## **CABINET MEMBER FOR ENVIRONMENT - 24 JULY 2014**

### **FRIDESWIDE SQUARE, OXFORD – TRANSPORT AND PUBLIC REALM IMPROVEMENTS ENABLING WORKS**

**Report by Deputy Director of Environment & Economy (Commercial)**

**Drawing title**  
Becket Street, Osney Lane & Hollybush Row TRO Changes  
Annex 2

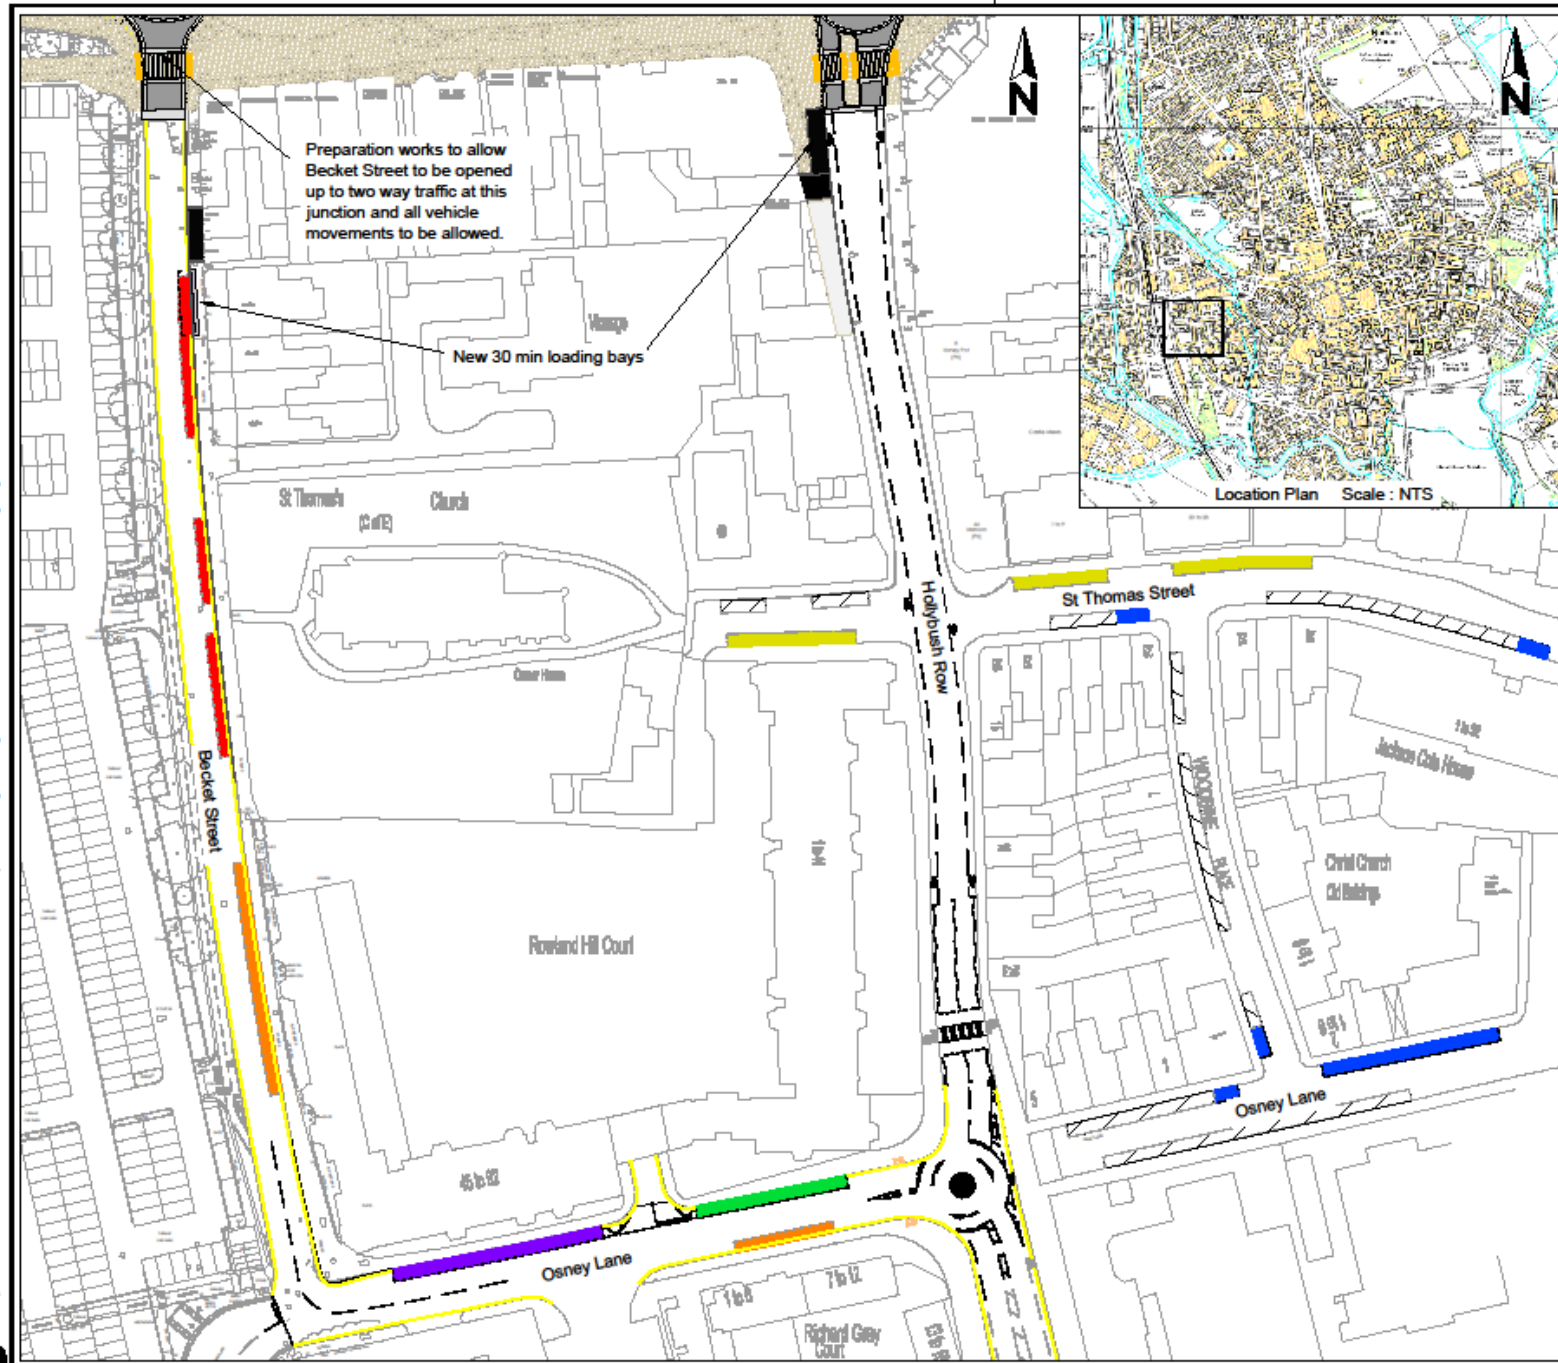
22. Objections to the TROs were generally based on;
- Additional traffic leading to potential increase in noise, pollution, excessive speed which in turn results in poorer road safety and quality of life.

- Reduced levels of on street parking for both resident permit holders and visitors and the fact that those spaces retained are further away than where people want/need them.

- Disabled parking spaces have not been catered for.
  - Lack of delivery/loading spaces to cater for the businesses on Frideswide Square.
  - Lack of enforcement of the existing loading bay restrictions.

- Lack of consideration given to refuse collections.
  - Not enough consideration given to improvements for pedestrians and cyclists.
  - Becket Street and Osney Lane are not suitable for large vehicles including buses.

- There is no proposal to provide bays specifically for disabled parking. However, blue badge holders can park in residents parking spaces for an unlimited time. Some additional residents spaces are available in St Thomas Street west of Hollybush Row. As part of the design refinement the possibility of adding some provision for blue badge holders in Becket Street and/or Hollybush Row will be investigated. Any additional provision would need to be separately advertised.

- The proposals include for the provision of two loading bays, one to the northern end of Becket Street and one the north end of Hollybush Row. These will replace the one that currently exists within Frideswide Square.

- Improvements for pedestrians and cyclists are being considered as part of these proposals including e.g. improvements to the zebra crossing on Hollybush Row and a cycle bypass at the proposed mini-roundabout.

31. **The Cabinet Member for Environment is RECOMMENDED to approve:**
  - (a) **the making of the Traffic Regulation Order amendments for Becket Street, Osney Lane, St Thomas Street and Woodbine Place, as advertised and shown in Annex 2 to this report;**

**Drawing title**  
Worcester Street Junction  
Annex 3

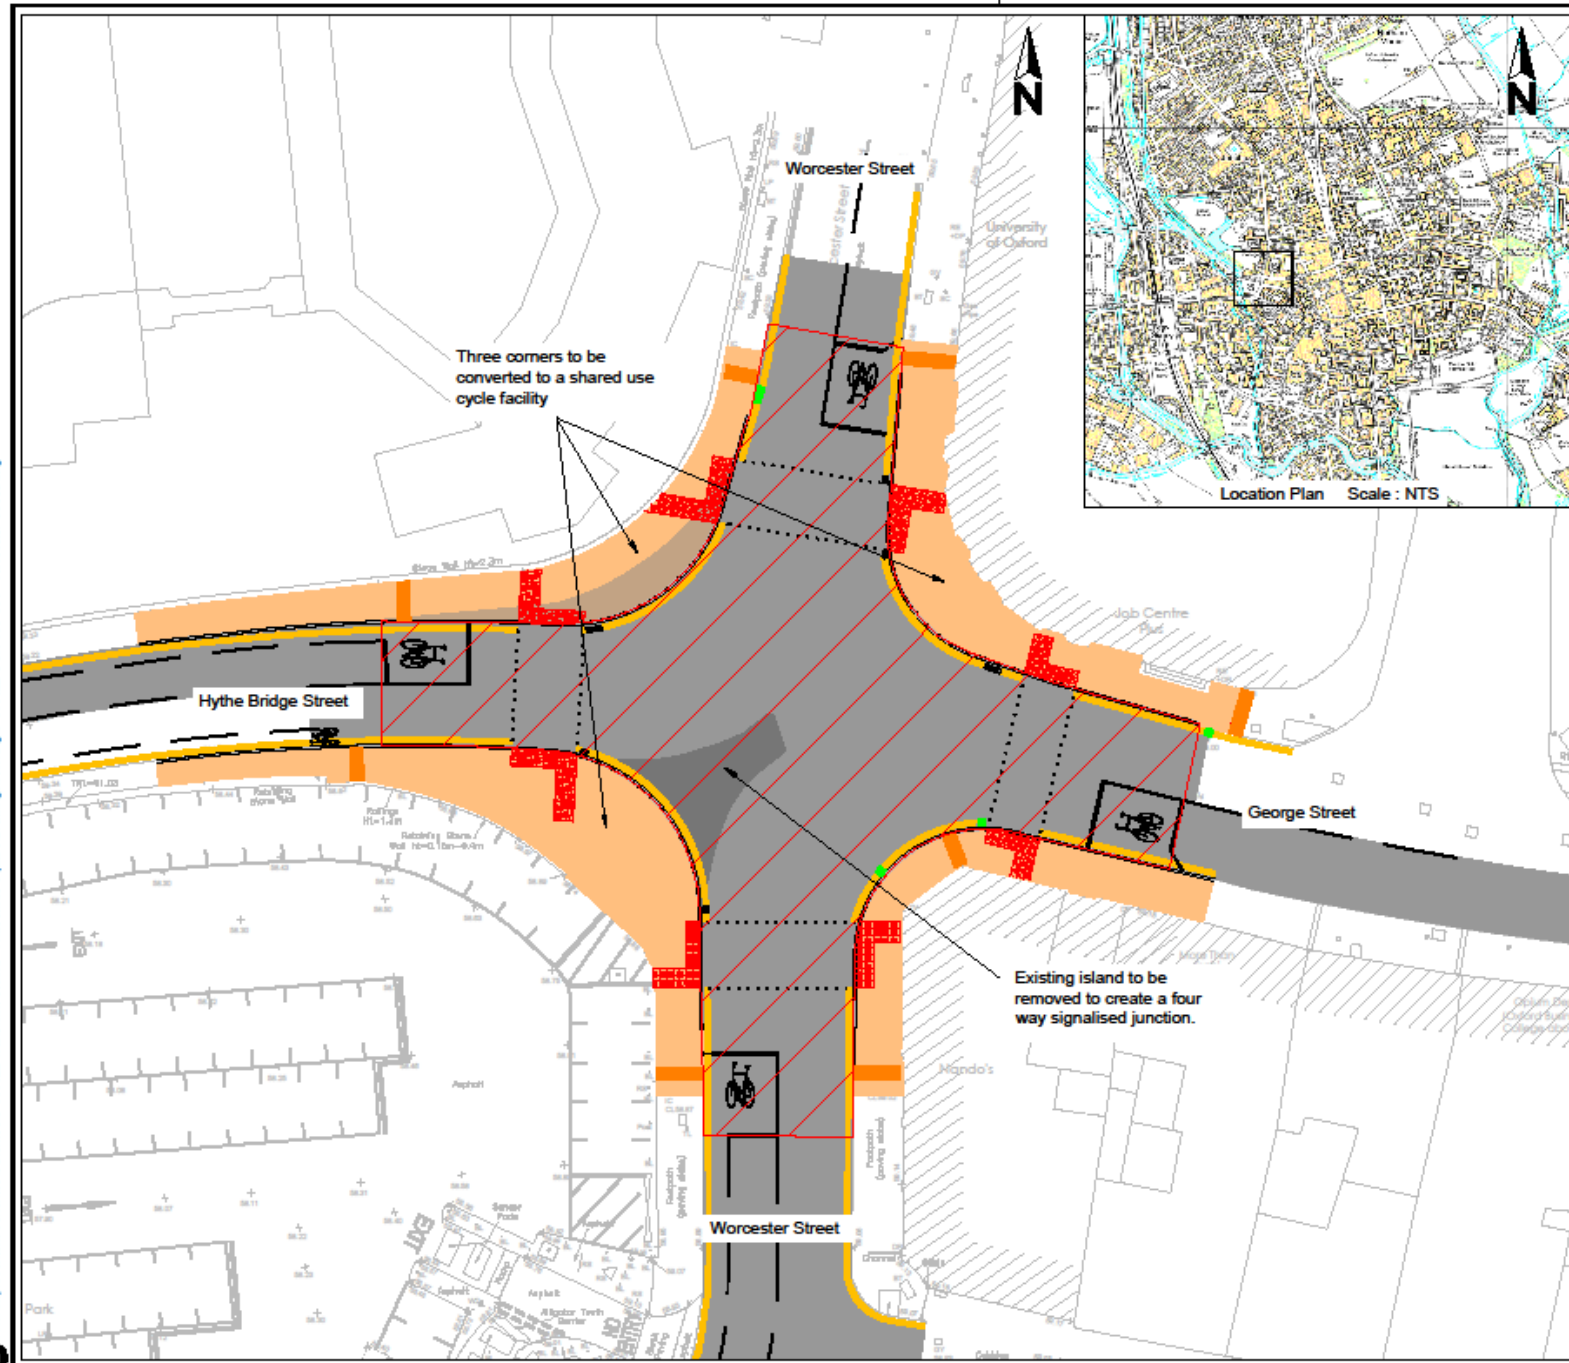
- Lack of regular communication with stakeholders.
  - Pedestrian desire lines are not catered for at the proposed Worcester Street junction and will incur delays.

- Shared use pavement areas at Worcester Street junction are generally not considered wide enough and will put pedestrians and cyclists in direct conflict.

25. The conversion of footway areas to unsegregated shared use at the Worcester Street junction has generated most responses. In response, officers recommend that approval to the conversions be granted but their physical implementation on the ground should be deferred until such a facility is considered required following monitoring of the junction after its construction. This would mean that the signalised junction would incorporate pedestrian phase elements only at initial installation.

- (b) **the conversion of footway areas to shared use at the Worcester Street/George Street/Hythe Bridge Street junction, shown in Annex 3 to this report but not its implementation at this time. Monitoring should be undertaken with a view to implementing later should the need arise;**
